Watts Bar Nuclear Plant, Unit 2  
NRC Docket No. 50-391

**Subject: REQUEST FOR ADDITIONAL INFORMATION REGARDING  
SUPPLEMENTAL CONDENSER COOLING WATER VELOCITY  
(TAC No. MD8203)**

**ENCLOSURE  
TVA RESPONSE TO  
REQUEST FOR ADDITIONAL INFORMATION REGARDING  
SUPPLEMENTAL CONDENSER COOLING WATER VELOCITY – WBN U2**

Figure 4. Sectional View Showing Path of Flow Through Screen House

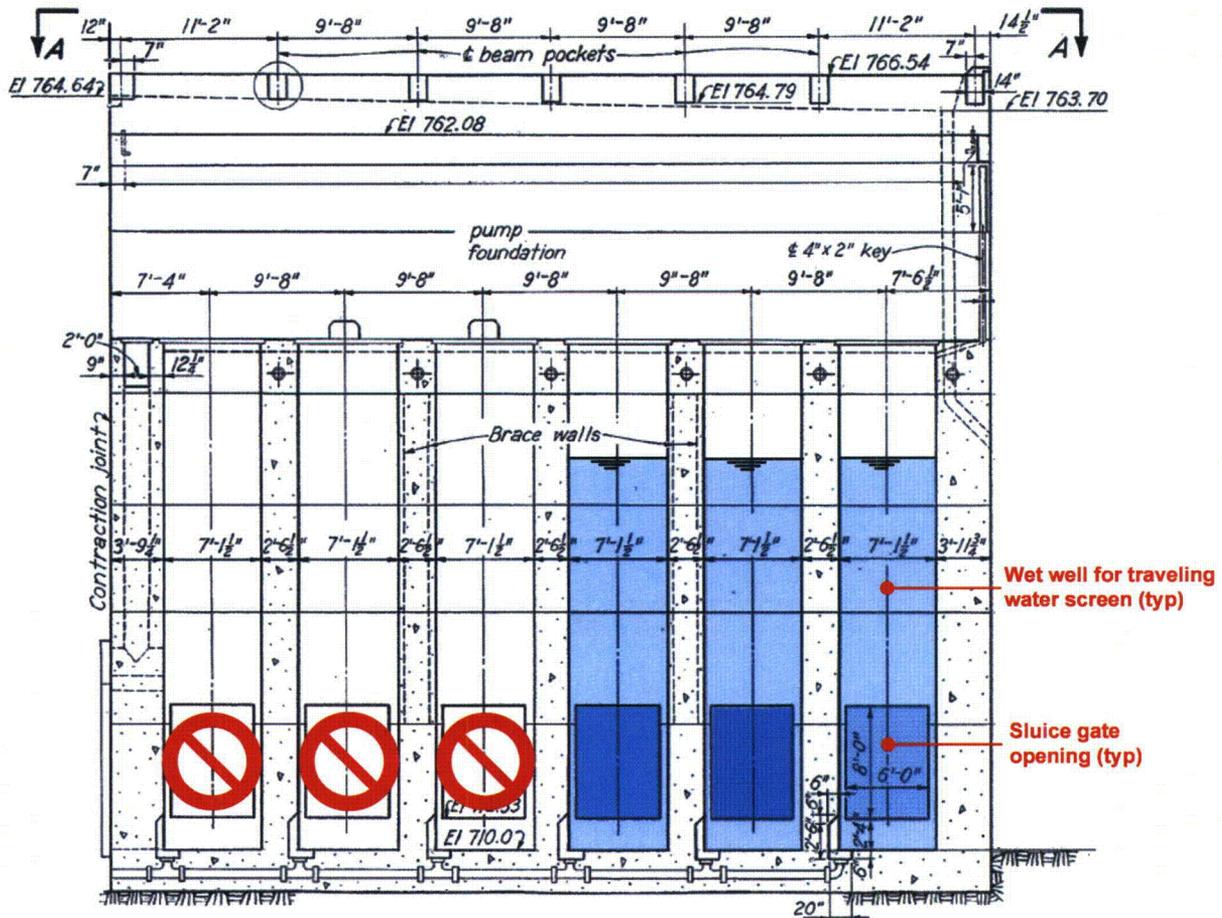
*A diagram and a written description of the SCCW intake, the flow rate, and velocity at the SCCW intake. Include in this description the intake flow rate, the expected velocity entering the screen house through the intake sluice gates, into the wet well for the traveling water screens, through the SCCW trashracks, and through the screens for both summer and winter pools. (This description would be similar to that provided in your May 19, 2011, letter to the NRC, "Watts Bar Nuclear Plant (WBN) Unit 2 – Intake Pumping Station Water Velocity – Response to Request for Additional Information" (Accession No. ML11143A083)).*

A section view through one of the intake bays is shown in Figure 3. Moving along the path of flow, water from Watts Bar Reservoir enters each bay through an opening about 19.59 feet high and 7.67 feet wide. The opening is always submerged and includes a trashrack to protect the screen house from large debris. The invert elevation of the opening is 710 ft msl. Downstream of the intake opening, the flow in each bay enters a wet well containing an "outside" sluice gate, and then another wet well containing a traveling water screen. The outer wet wells are 7.67 feet wide and the wet wells containing the traveling water screen are 7.125 feet wide (see Figure 4). Downstream of the traveling water screens, the flow from all the active intake bays enters a common wet well containing "inside" sluice gates. This wet well directs the water to a tunnel that leads to supply lines for the SCCW intake conduit. All the wet wells have an invert elevation of 710 feet msl and contain a free surface that moves up and down in response to changes in the water surface elevation in Watts Bar Reservoir. The outer and inner sluice gates are provided to isolate the wet wells for the traveling water screens and the wet well for the supply tunnel. The gated openings are 6 feet wide and 8 feet high and are always submerged (see Figure 5).

**Figure 7.** Estimated vs. Computed Values of the SCCW intake flow rate for March 1, 2010 through March 1, 2011;  $QIN_R = 305 \text{ cfs}$ ,  $HWEL_R = 740.5 \text{ ft msl}$ ,  $WSELT2_R = 731.6 \text{ ft msl}$ .

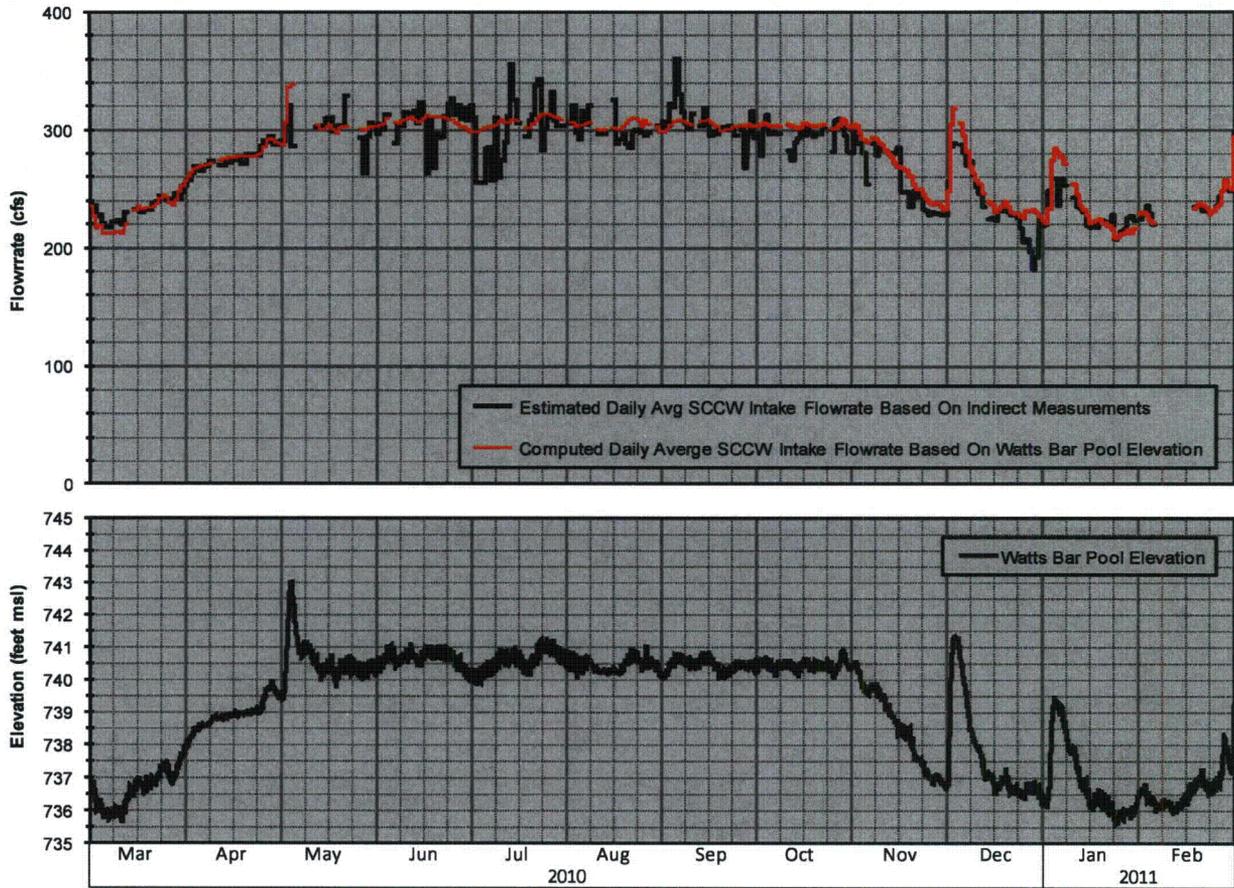
A written explanation of the differences among the intake flow rates presented in Attachment H-14 (Table 10) and those in Attachment H-12 of the February 2010, RAI response, April 2011, RAI response, and the 2012 "Estimates of Entrainment of Fish Eggs and Larvae at Watts Bar Nuclear Plant" document. The staff used the numbers from Attachment H-14 (Table 10) of the letter dated February 25, 2010, as the basis for the water balance provided in the Final Environmental Statement (FES). These numbers are not consistent with the numbers provided for intake flow rate to the SCCW and/or the intake pumping station (IPS) in the Attachment H-12 and/or H-11 of the February 25, 2010, RAI response, April 2011, RAI response, and the 2012 "Estimates of Entrainment of Fish Eggs and Larvae at Watts Bar Nuclear Plant" document. The staff understands that the numbers reflect different operational scenarios such as nominal vs. maximum flows, nominal vs. minimum seasonal pool level, etc.

Using Equation (2),  $QIN_{SCCW}$  can be estimated based on indirect observations or estimates of the other parameters in the equation. Briefly,  $QIN_{ERCW}$  and  $QOUT_{SCCW}$  are metered by plant instrumentation,  $QIN_{RCW}$  can be estimated based on the number of RCW pumps in service,  $QOUT_{BD}$  can be estimated based on the volume of blowdown entering the plant low volume waste holding pond, and  $QOUT_{EVAP}$  can be estimated based on the plant generation. The observations and/or estimates of each of these parameters contain uncertainties, so bias and statistical scatter is imbedded in the resulting estimates for  $QIN_{SCCW}$ . By this process, the resulting estimates for the daily average SCCW intake flow rate (i.e.,  $QIN_{SCCW}$ ) for the period of study are shown in Figure 7.

A regression analysis was performed to update the values of  $QIN_R$  and  $WSELT2_R$  -- in particular, values producing a minimum mean-square difference between  $QIN_{SCCW}$  computed from Equation (1) and  $QIN_{SCCW}$  estimated from Equation (2). The analysis also required historical data for the pool elevation behind Watts Bar Dam, which also is shown in Figure 7. Since the water surface elevation in the Unit 2 cooling tower basin was

$QIN_R = 305 \text{ cfs}$  (or  $136,884 \text{ gpm}$ ) and  
 $WSELT2_R = 731.6 \text{ ft msl}$ . (Note this level is a curve fit parameter, not a physical basin elevation)
